## HISTORIC AND DESIGN REVIEW COMMISSION

**HDRC CASE NO:** 2025-135  
**ADDRESS:** 240 E LULLWOOD AVE  
**LEGAL DESCRIPTION:** NCB 6727 BLK 3 LOT 21 AND 22  
**ZONING:** RM-4, H  
**CITY COUNCIL DIST.:** 1  
**DISTRICT:** Monte Vista Historic District  
**APPLICANT:** KRISTEN WEBER/Lullwood Studio  
**OWNER:** KRISTEN WEBER/WEBER KRISTEN L & DANIEL R STACY  
**TYPE OF WORK:** New construction of a 2-story rear accessory structure  
**APPLICATION RECEIVED:** May 15, 2025  
**60-DAY REVIEW:** July 14, 2025  
**CASE MANAGER:** Bryan Morales  
**REQUEST:**

The applicant is requesting a Certificate of Appropriateness for approval to construct an approximately 1,992 sf 2-story rear accessory structure.

[illegible]

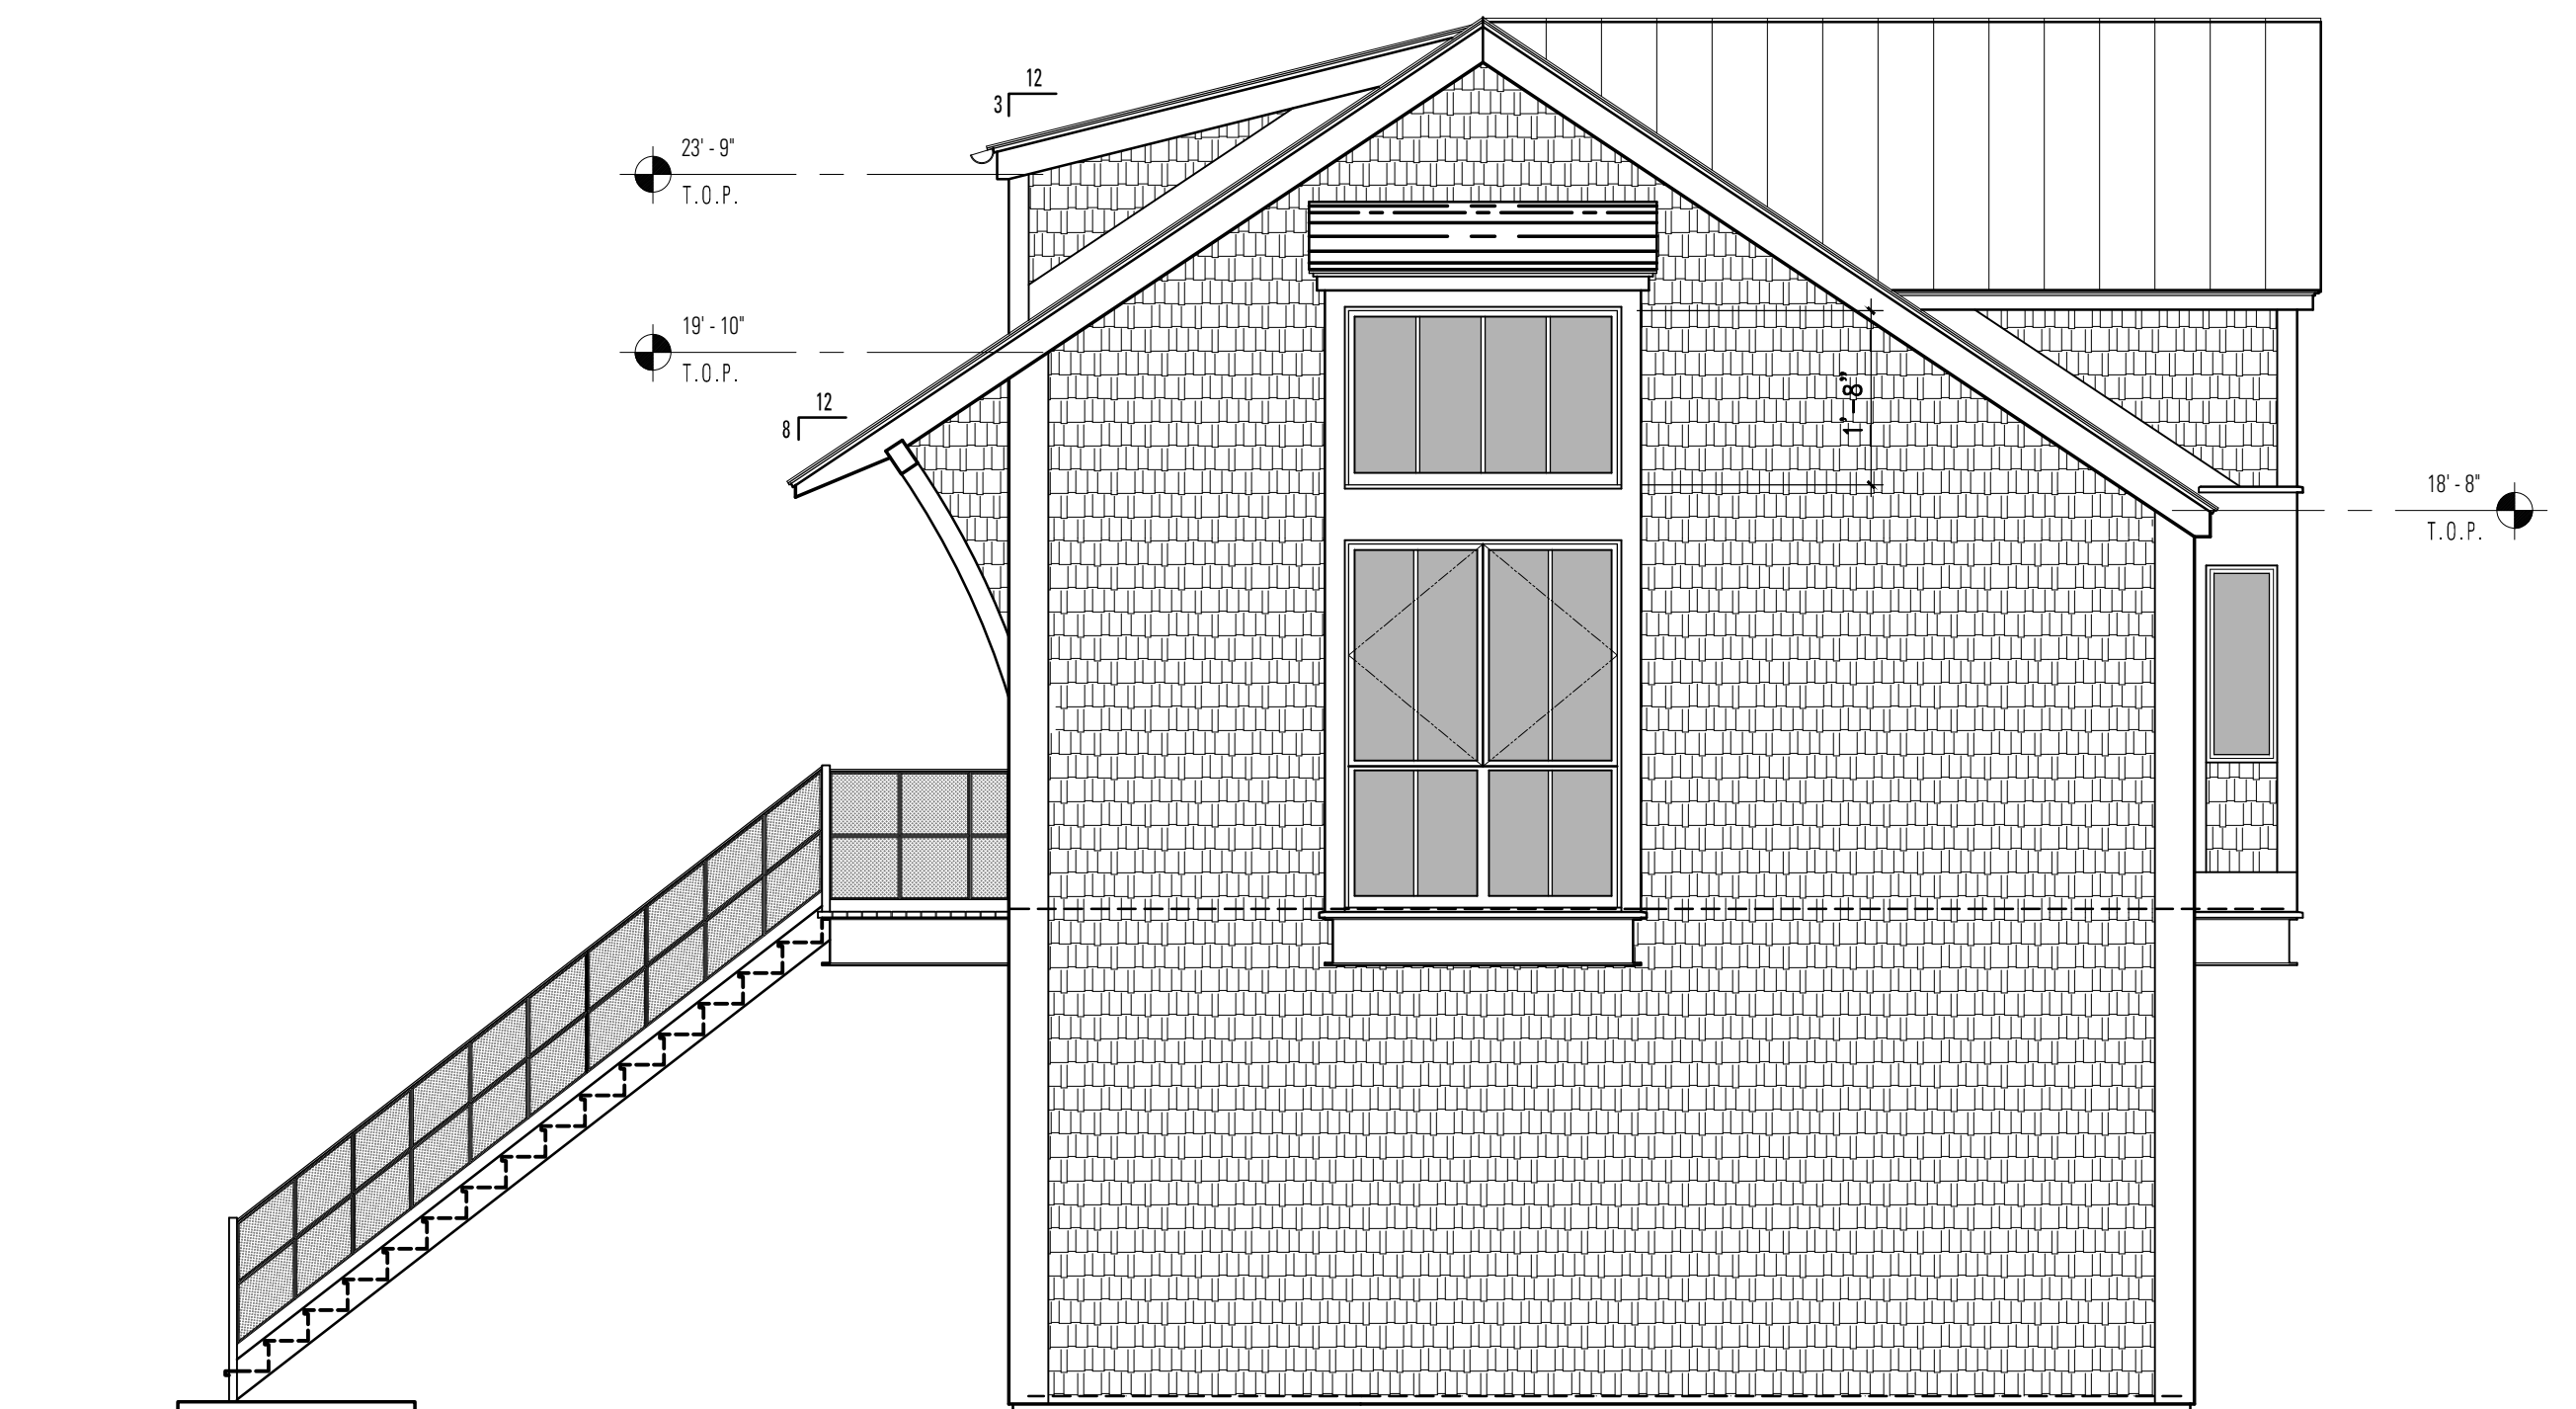
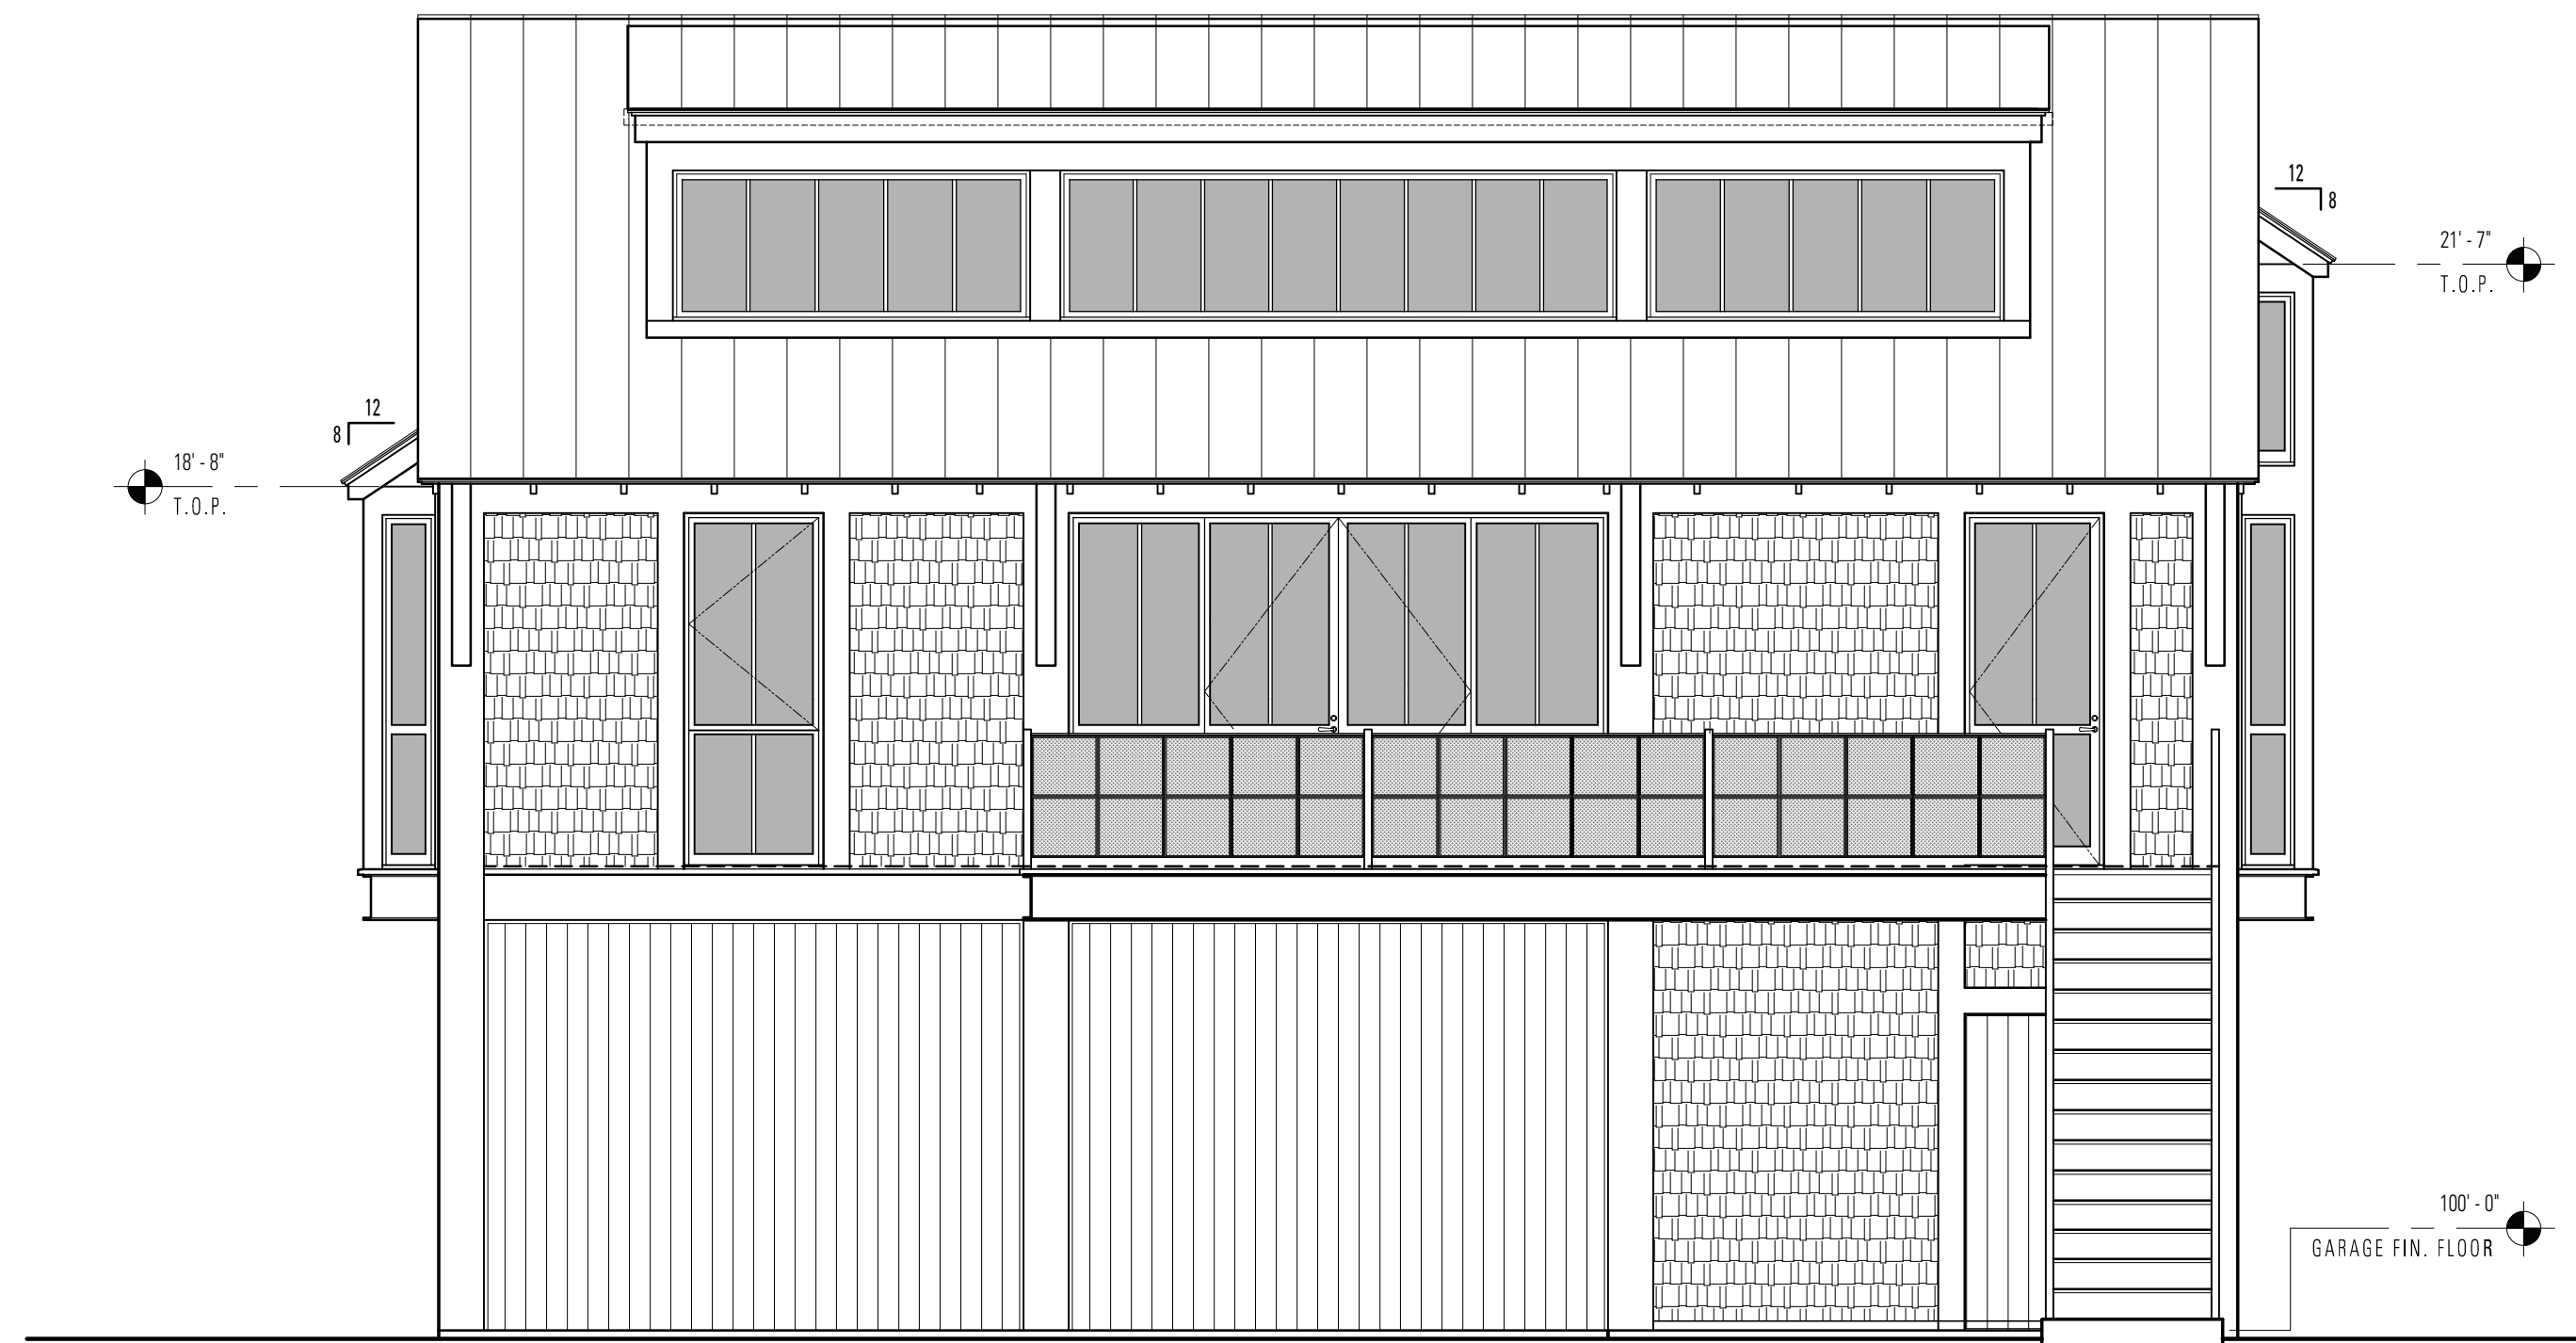
- f. ROOF FORM & MATERIAL – The applicant is requesting approval to construct a 2-story rear accessory structure with a garage featuring a side-facing standing seam metal gable roof, a north-facing dormer, and a south-facing gable. New Construction 5.A.iii. and 5.A.iv. note that new accessory structures should relate to the period of construction of the primary historic structure on the lot by using complementary materials and simplified architectural details. Staff finds the roof forms and material conforms to Guidelines.

- g. ARCHITECTURAL DETAILS – The applicant is requesting approval to construct a 2-story accessory structure at the rear of the property featuring a double-bay with two garage doors; two-over-two, one-over-one, and fixed windows; second-story balcony at the north façade; an oriel at the east façade; and an oriel at the west façade. The Guidelines for New Construction 5.A.iii. and 5.A.iv. note that new accessory structures should relate to the period of construction of the primary historic structure on the lot by using complementary materials and simplified architectural details. Staff finds the proposed architectural details generally appropriate.

- i. **ARCHITECTURAL DETAILS (FENESTRATION PATTERN)** – The applicant is requesting approval to install three single doors, three dormer windows, a fixed window, two one-over-one windows, two garage doors, and four two-over-two windows on the north façade; one fixed window, two two-over-two windows, and a gable window on the east façade; one fixed window and two one-over-one windows on the south façade; and five fixed windows and two two-over-two windows on the west façade. New Construction 2.C.i. related to window and door openings stipulates to incorporate window and door openings with a similar proportion of wall to window space as typical with nearby historic facades. Staff finds the proposed fenestration pattern generally appropriate.

- i. That the applicant installs a fully wood or aluminum-clad wood window that meet staff's standard window stipulations and submits updated specifications to staff for review and approval. The windows should feature an inset of two (2) inches within facades and should feature profiles that are found historically within the immediate vicinity. Meeting rails must be no taller than 1.25" and stiles no wider than 2.25". White manufacturer's color is not allowed, and color selection must be presented to staff. There should be a minimum of two inches in depth between the front face of the window trim and the front face of the top window sash. This must be accomplished by recessing the window sufficiently within the opening or with the installation of additional window trim to add thickness. Window trim must feature traditional dimensions and architecturally appropriate sill detail. Window track components must be painted to match the window trim or concealed by a wood window screen set within the opening.

- ii. That the applicant install a standing seam metal roof featuring panels that are 18 to 21 inches wide, seams that are 1 to 2 inches high, a crimped ridge seam, and match the current finish or a standard galvalume finish. Panels should be smooth without striation or corrugation. Ridges are to feature a double-munch or crimped ridge configuration; no vented ridge caps or end caps are allowed. All chimney, flue, and related existing roof details must be preserved. An inspection must be scheduled with OHP staff prior to the start of work to verify that the roofing material matches the approved specifications. No modifications to the roof pitch or roof form are requested or approved at this time.

- iii. That the applicant install a fully wood garage door or a garage door with a design that mimics wood construction and features a smooth finish without a faux wood grain texture. Final garage door specifications must be submitted to staff for review and approval prior to the issuance of a Certificate of Appropriateness.
